**Permit #:** 61**Permit Date:** 05/02/23**Permit Type:** Planning Commission**Case Number:** PC 23-22**PC Meeting Date:** h. 1st Tuesday of October**BZA Meeting Date:****Assigned Meeting Date:** 10/03/2023**Special Meeting Date:****Applicant Is:** Contractor**Applicant Name:** ELY Mandle**Applicant Address:** PO BOX 647**Applicant City, State, ZIP:** Oxford MS 38655**Applicant Phone Number:** 731-426-3964**Applicant Email:** ely@ascentnashville.com**Description:** Proposed structurally supported parking pad constructed in the steep slope.**Project Cost:** 2000**Square Feet:** 0**Lot Area:** 0**Lot Coverage:** 0**Heat/cooled area:** 0**Proposed Height(ft.):** 0**#of stories:** 0**Lot Depth/Width Ratio:****Avg. front setback of adjacent homes:****Zoning District:** Zone C**Radnor Lake Impact Zone:** Yes**Steep Slope:** Yes**Plat/Subdivison:** No**Status:** Open**Assigned To:** Steve Mallory**Property**

## MEMORANDUM

Subject: PC Case 23-22, Radnor Lake Impact Zone and Steep Slope Site Plan for 5031 Lakeview Drive

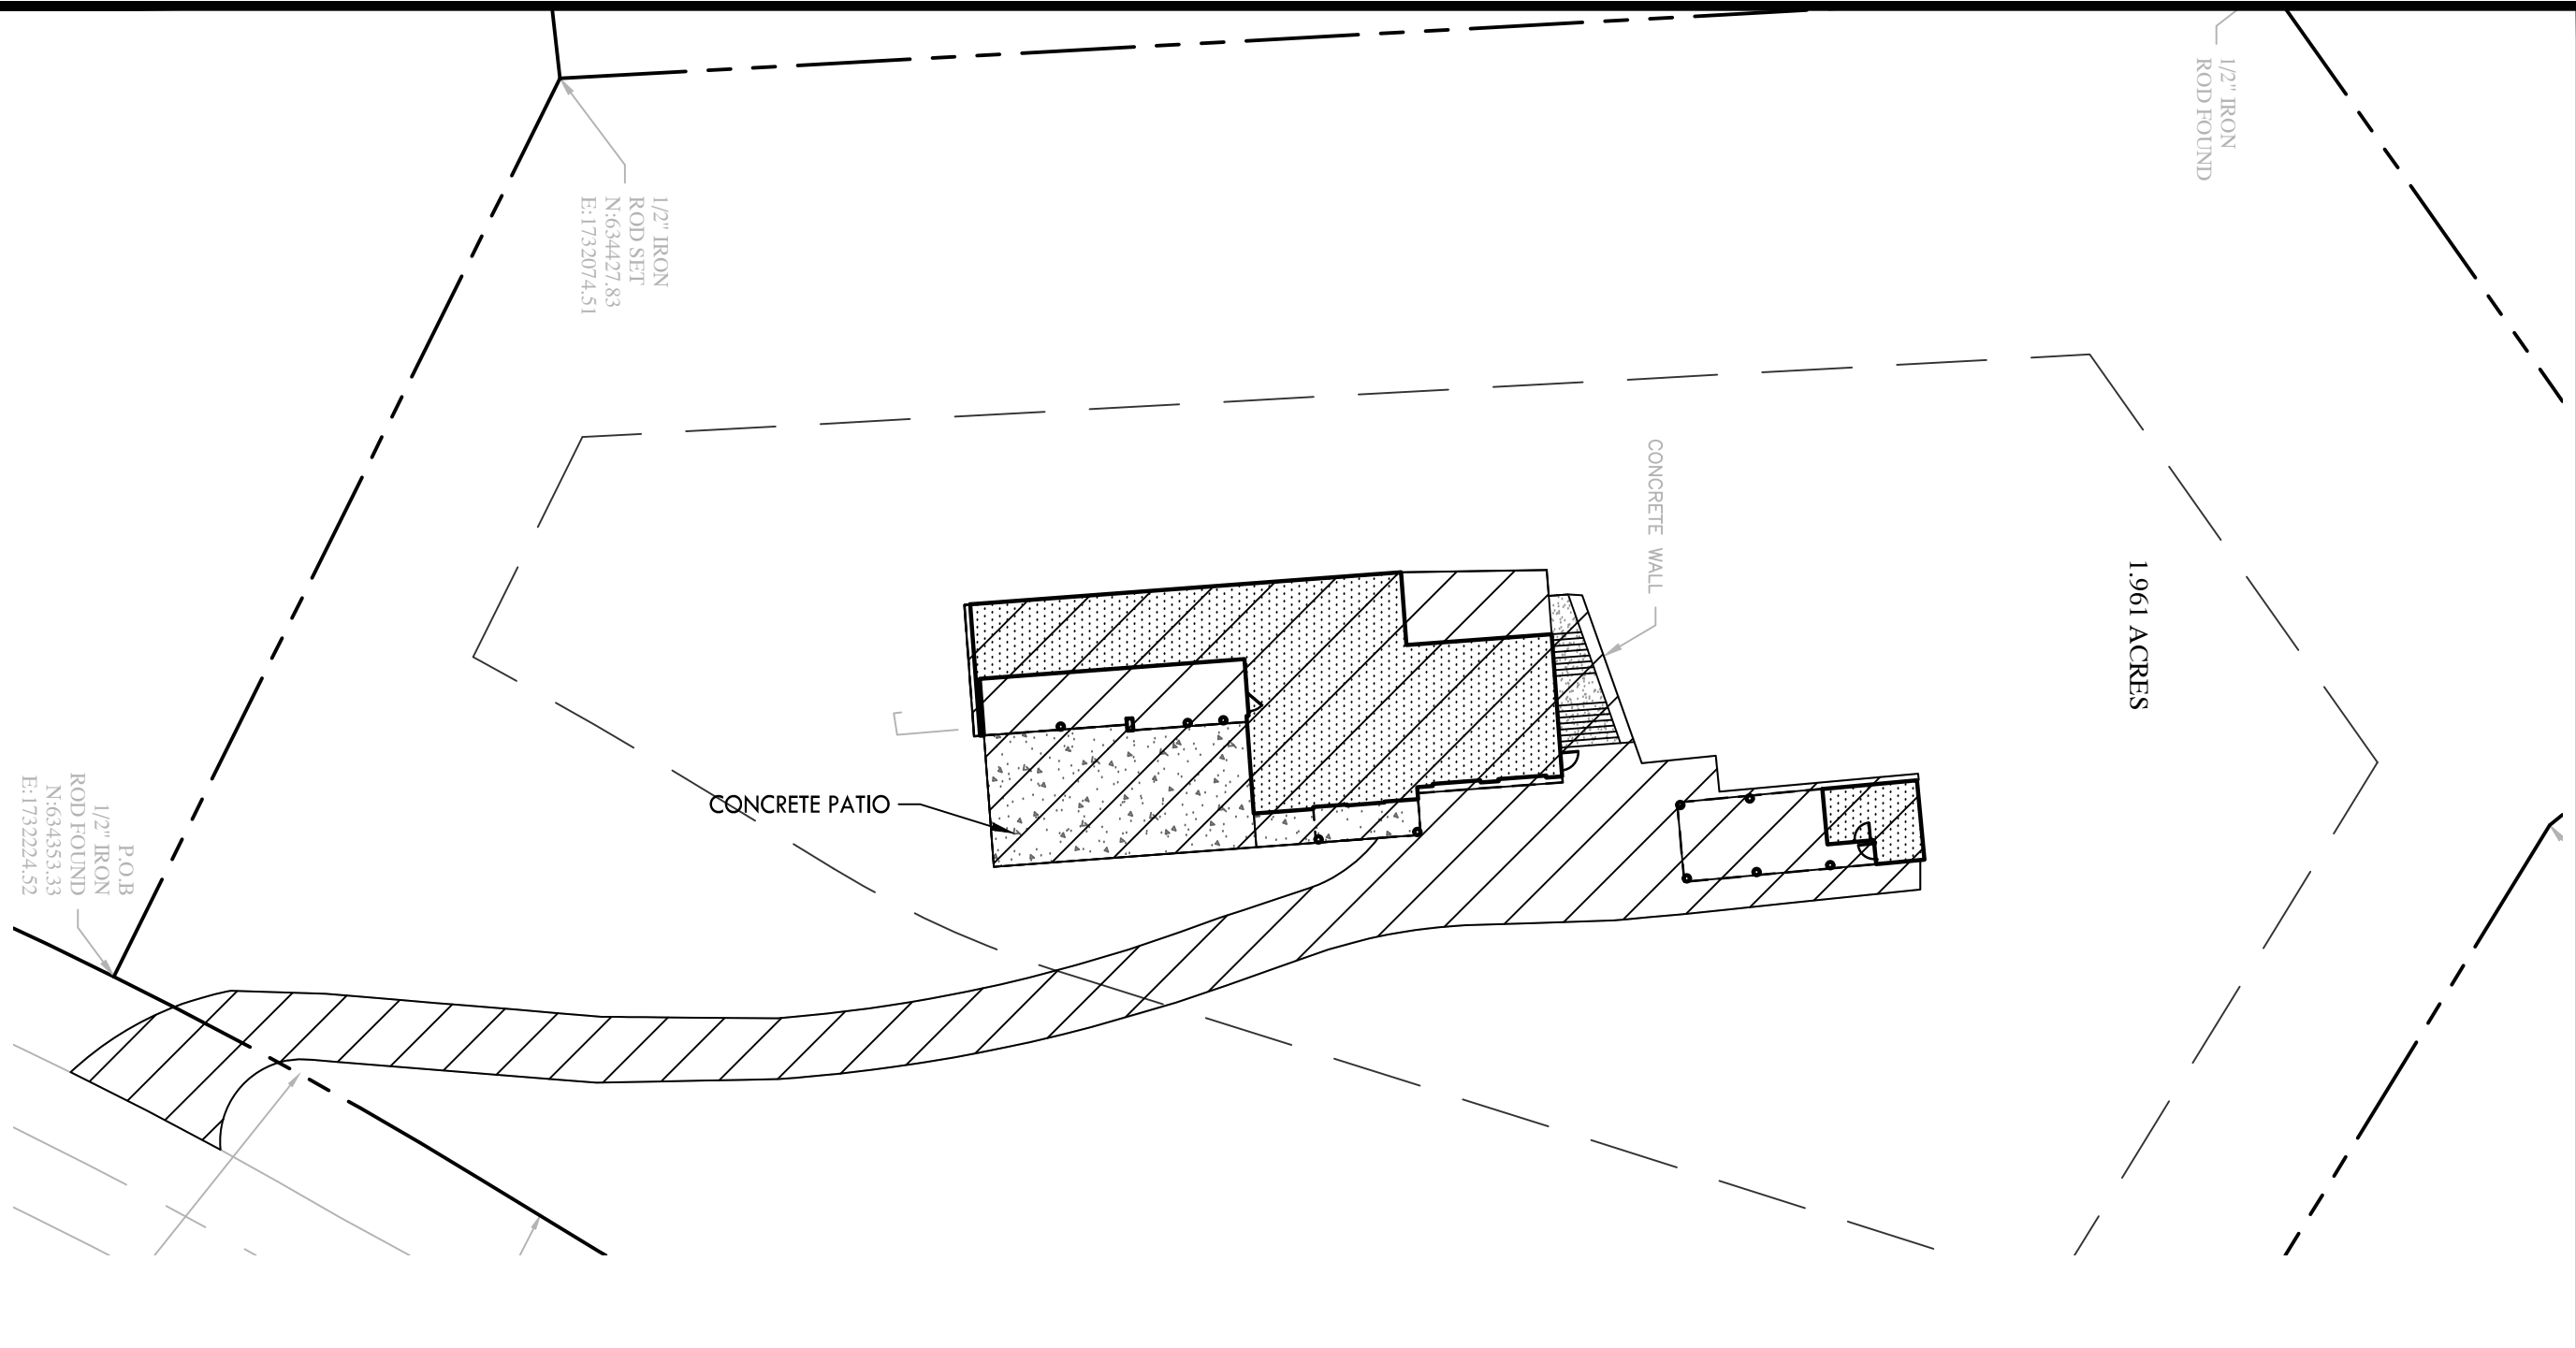
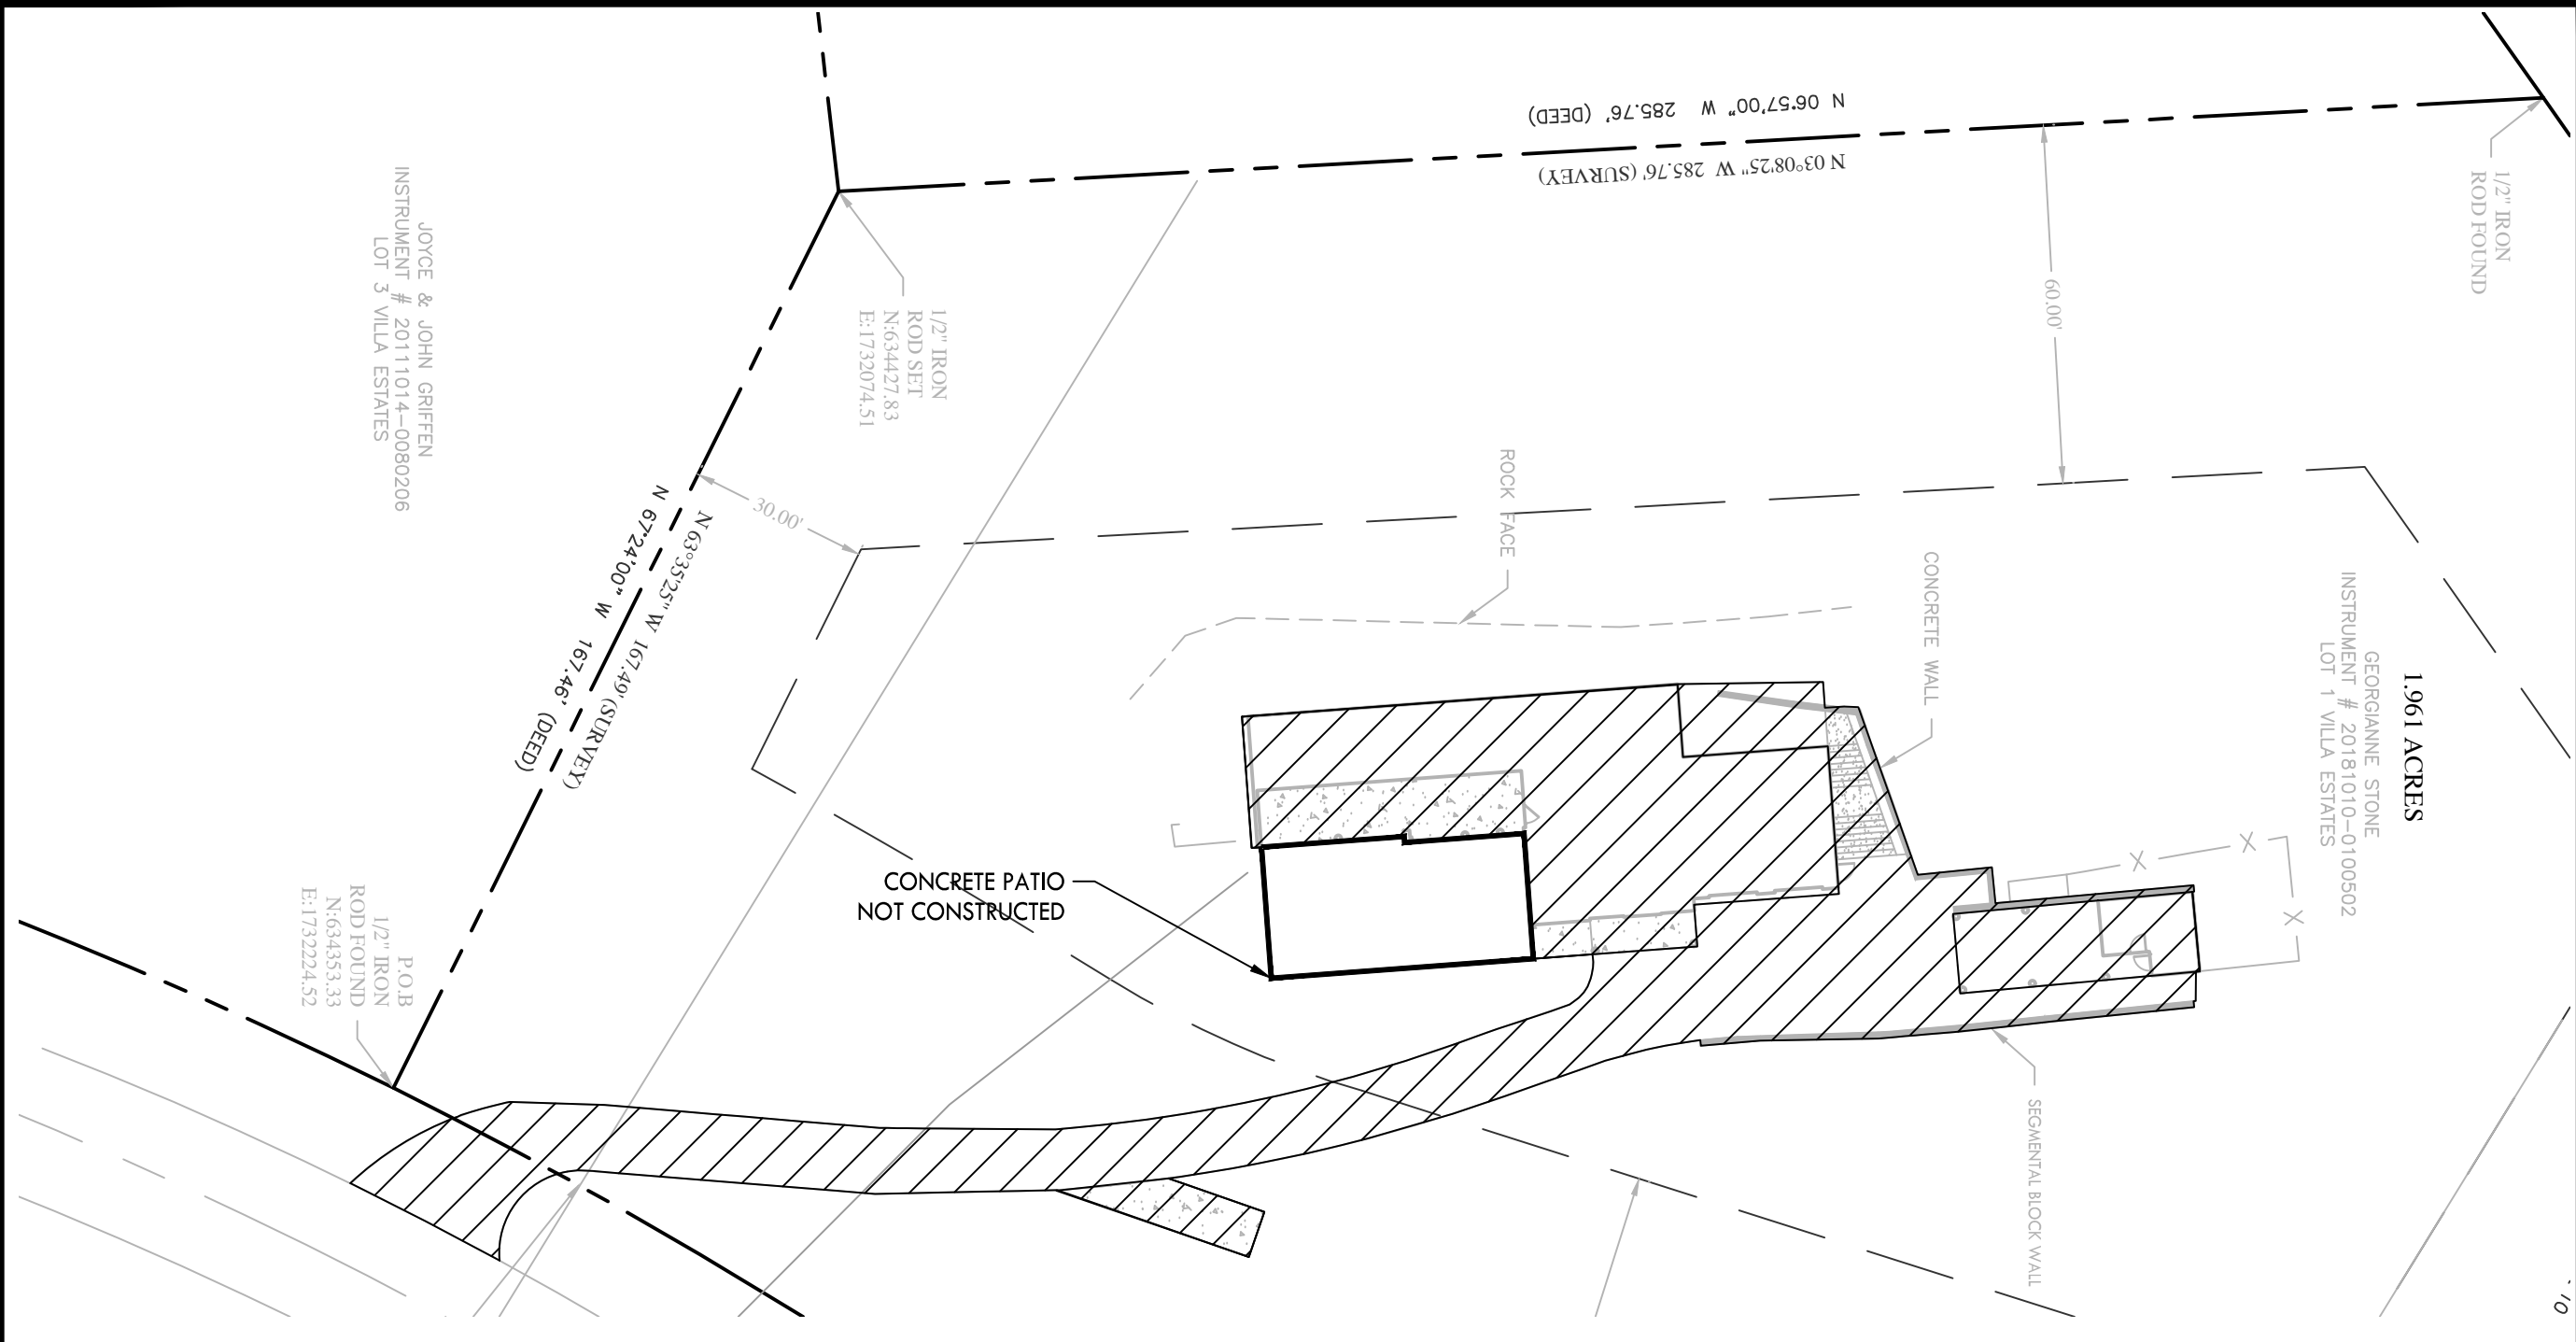
1. Show the proposed pool equipment pad on the site plan.
  - a. Provided. This has been removed as the pool was not approved for a variance at BZA.
2. Provide stormwater management for the added impervious area.

- a. Stormwater management is not required for the parking pad since it is taking the place of the concrete patio that was originally approved and permitted as impervious area with the original design. This concrete patio was not built resulting in a decrease in impervious area of 947 sf from the original approved plans. The parking pad is 528 sf. Therefore, there is still a net decrease of 419 sf of impervious area from the original approved design plans.
